Corridor Review Table

CORRIDOR 8-104 REVIEW			
POTENTIAL COMPATIBILITY ISSUES or CONCERNS TO EXAMINE	MILEPOST (MP)¹	STAKEHOLDER INPUT and OTHER RELEVANT INFORMATION	POTENTIAL RESOLUTIONS BASED ON SITING PRINCIPLE ANALYSIS²
<i>USFS Jurisdiction: Modoc National Forest</i>			
<i>Agency Land Use Plan: Modoc NF LMP (1991)</i>			
GRSG GHMA intersects and is adjacent to the corridor—The LMP does not prescribe restrictions for GHMAs within designated energy corridors. No changes to the LMP were included in 2015 GRSG amendments to USFS LMPs. The October 2018 USFS Draft EIS addressing planning issues for GRSG did not include California NFs, so no changes to GRSG management prescriptions in the Modoc NF are anticipated in the forthcoming ROD.	MP 0 to MP 11, MP 27 to MP 29, MP 33 to MP 48		There are no management prescriptions preventing future development within the corridor. GRSG GHMA encompasses a broad area around the corridor, which cannot be avoided. The location appears to best meet the siting principles because collocation (existing transmission and pipelines) is preferred.

Figure 3. Map of Conflict Areas in Vicinity of Corridor 8-104

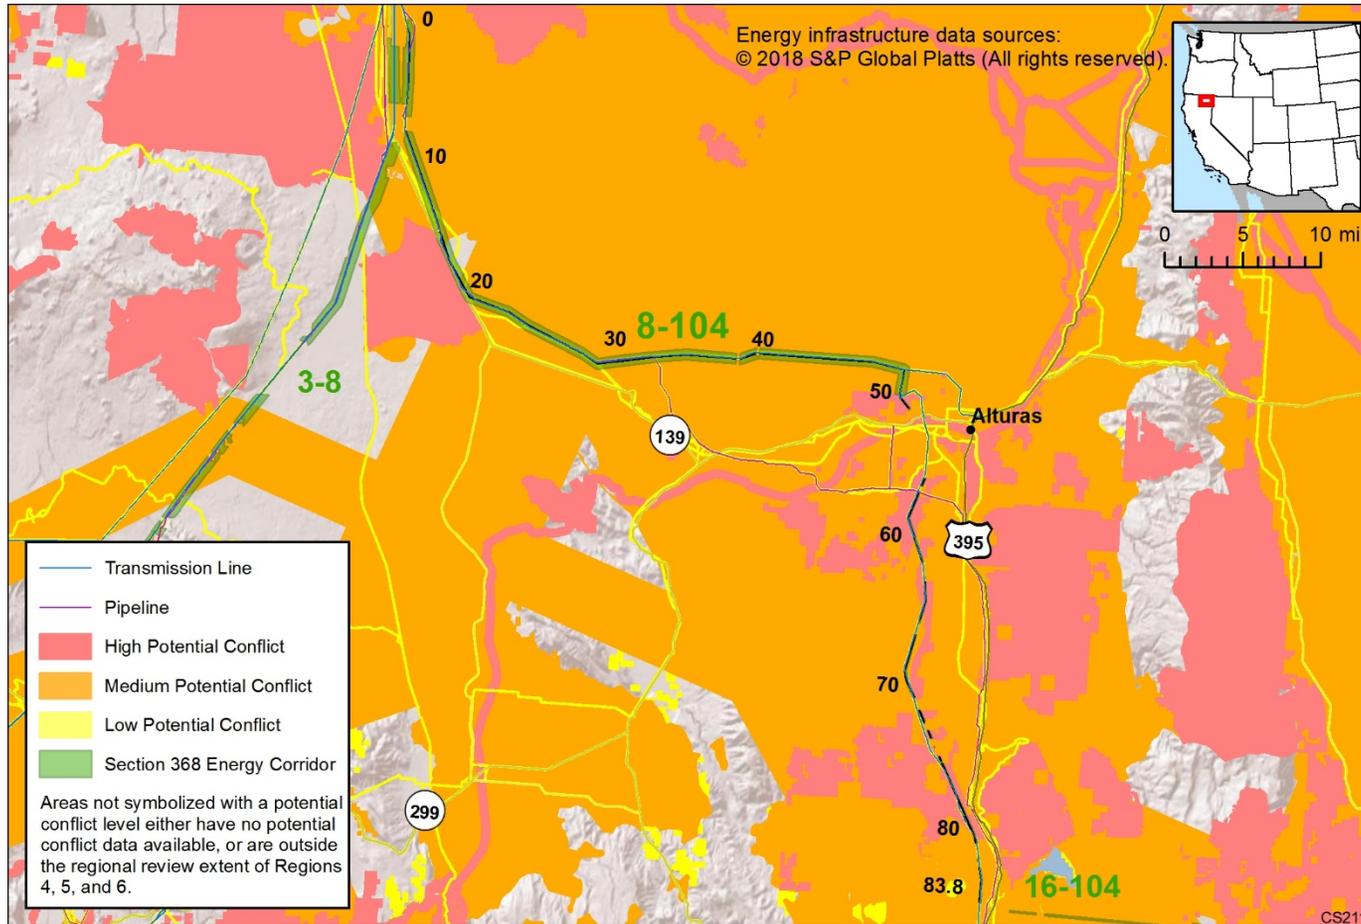
Figure 3 reflects a comprehensive resource conflict assessment developed to enable the Agencies and stakeholders to visualize a corridor’s proximity to environmentally sensitive areas and to evaluate options for routes with lower potential conflict. The potential conflict assessment (low, medium, high) shown in the figure is based on [criteria](#) found on the WVEC Information Center at www.corridoreis.anl.gov. To meet the intent of the Energy Policy Act and the Settlement Agreement siting principles, corridors may be located in areas where there is potentially high resource conflict; however, where feasible, opportunity for corridor revisions should be identified in areas with potentially lower conflict.

Figure 4. Corridor 8-104, Corridor Density Map

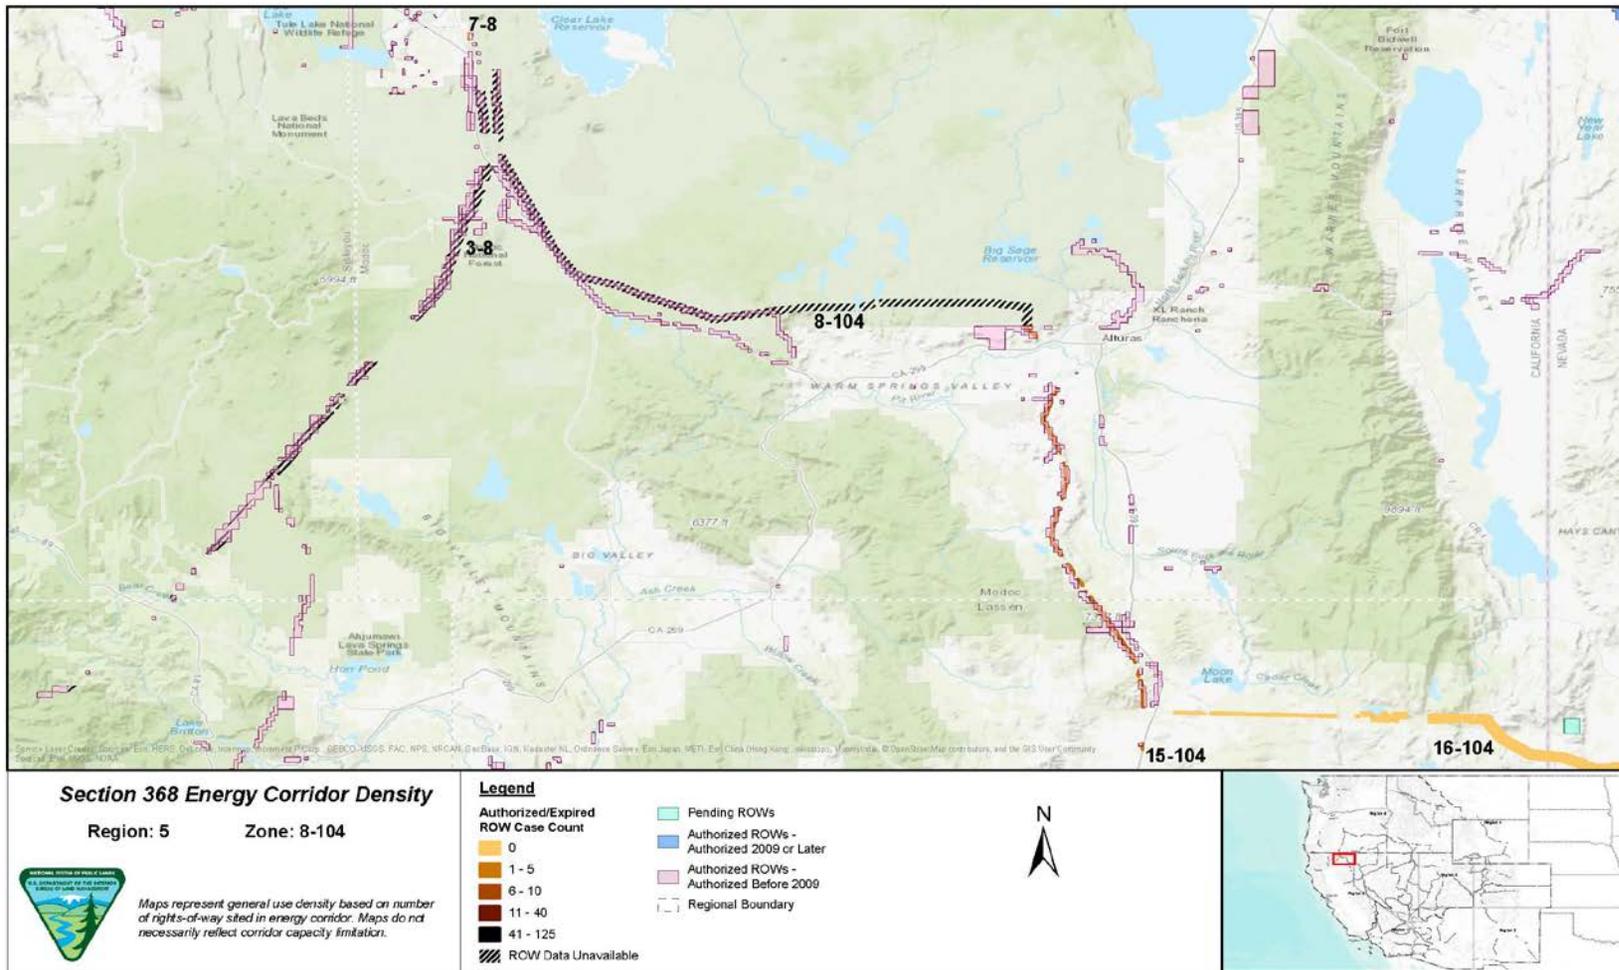
Figure 4 shows the density of energy use to assist in evaluating corridor utility. ROWs granted prior to the corridor designation (2009) are shown in pink; ROWs granted after corridor designation are shown in blue; and pending ROWs under current review for approval are shown in turquoise. Note the ROW density shown for the corridor is only a snapshot that does not fully illustrate remaining corridor capacity. Not all ROWs have GIS data at the time this abstract was developed. BLM and USFS are currently improving their ROW GIS databases and anticipate more complete data in the near future.
